## CORRECTION INDEX - MECANOGRAM

## I

CONDITION: Repeat addition from single key depression (electric machines).

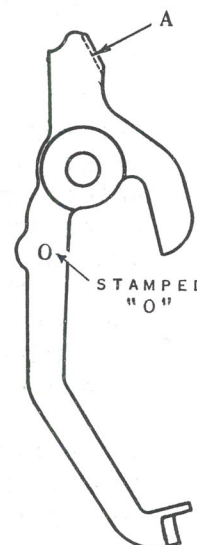
CAUSE: 1. Worn or chipped drive pawl.

2. Rebound of the adding sector when returning to normal may cause drive pawl AC (Plate 18, Symbol List) to slip off the shelf of latch AB (Plate 18) and re-engage the drive wheel.

CORRECTION: 1. Install new drive pawl 1A-56101. Hardening specifications for this pawl have been changed to prevent chipping and wearing.

2. Install new sector with stock removed from the drive pawl reverse arm at point A (illustrated). This alteration results in later reset of the drive pawl and reduces rebound of the sector thus obtaining a safer hold of the pawl on the latch.

New sectors ordered from stock are identified with an "O" stamped on the reverse arm. Sector part numbers remain the same.

All electric machines after Serial No. C36930S contain the new sector, however, only those machines beginning with Serial No. C39272 contain sectors stamped with an "O".
